Jobs/2419.00/Drainage/241900 FDR.doc

***PLATTE SELF STORAGE
AREA RUNOFF COEFFICIENT (C) SUMMARY***

PLATTE SELF STORAGE
SITE DEVELOPMENT PLAN
EXISTING DRAINAGE MAP
AUGUST 2024

PLATTE SELF STORAGE
SITE DEVELOPMENT PLAN
PROPOSED DRAINAGE MAP
AUGUST 2024

Figure 8-12. Inlet Capacity Chart Sump Conditions, Curb Opening (D-10-R) Inlet

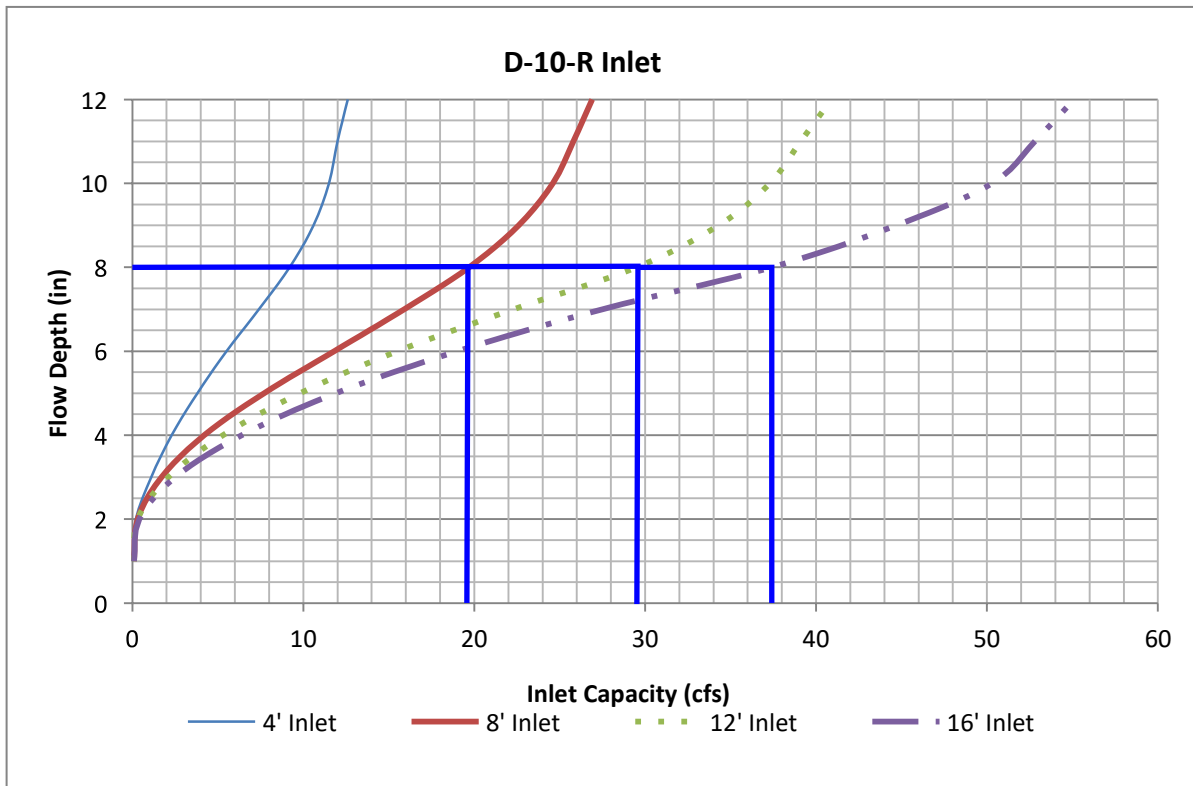
D-10-R inlets are used in the city. County uses CDOT Type R inlets. Please revise

MHFD Inlet spreadsheet has all 3 inlet types available (Type R, Type C and Type 13). Suggest using that spreadsheet for inlet design.

changed to Type R and updated calcs with correct chart for Type R and Type C

used for type 13 inlets that have by-pass flows at DP3A-3D

Pond Outlet

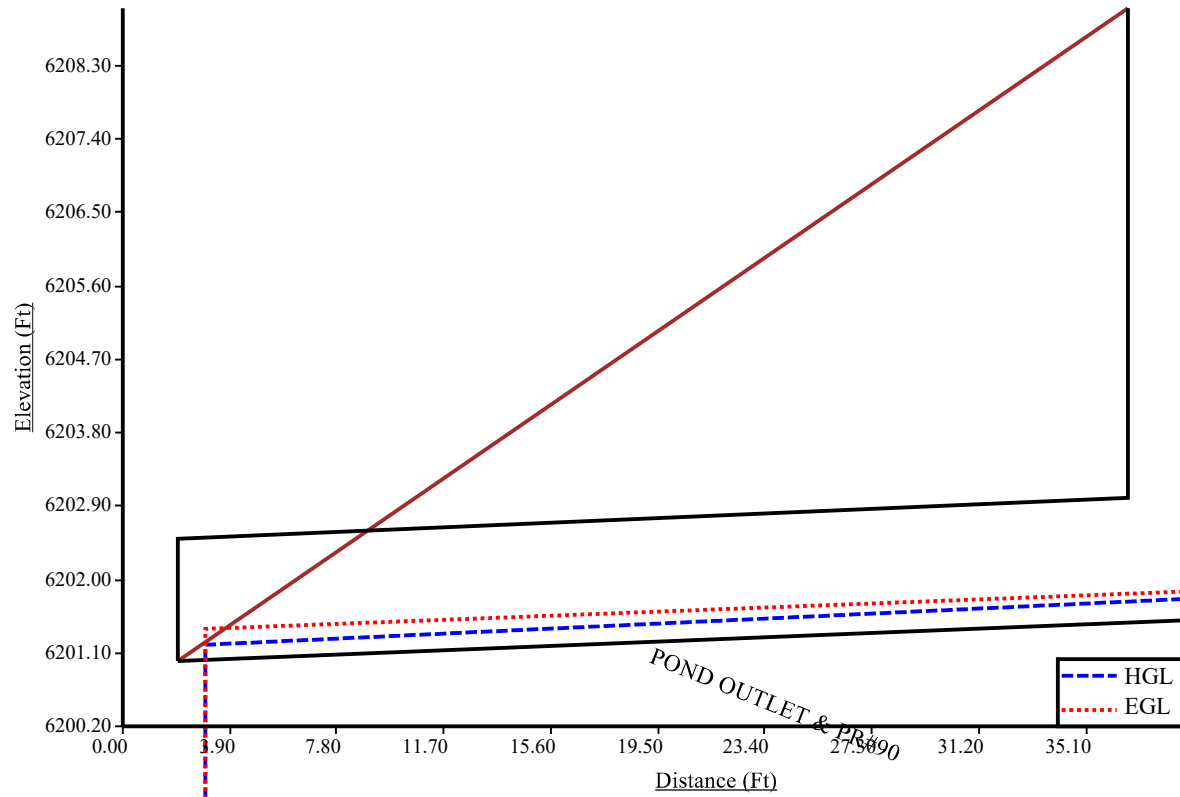
Why do these lines drop off? Verify input information

fixed

PROPOSED DRAINAGE MAP

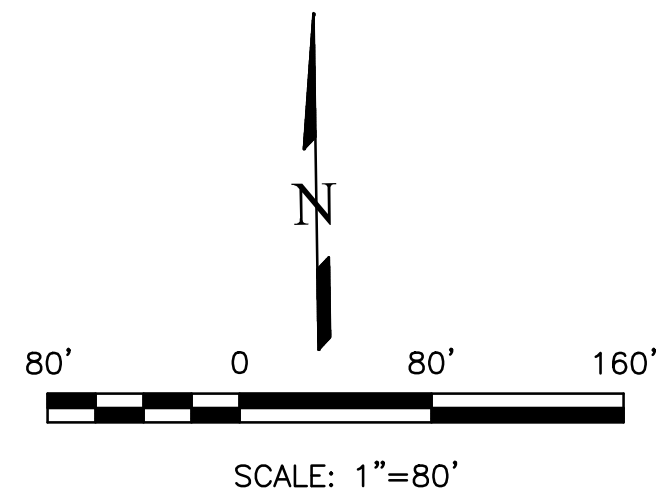
Unresolved:
Provide calculations in appendix
for sizing of stilling basin

Unresolved:
Please show & label all
drainage easements.

Unresolved:
Include slope of each
swale. Calculations in
appendix all swales use
n-value for concrete, not
grass, please revise
calculations to
appropriately reflect design
parameters of swales or
include calculations for
swales which have not
been included.

See Appendix
for notes

We have shown
a ditch and
access point for
pond and road

See Appendix
for notes

See Appendix
for notes
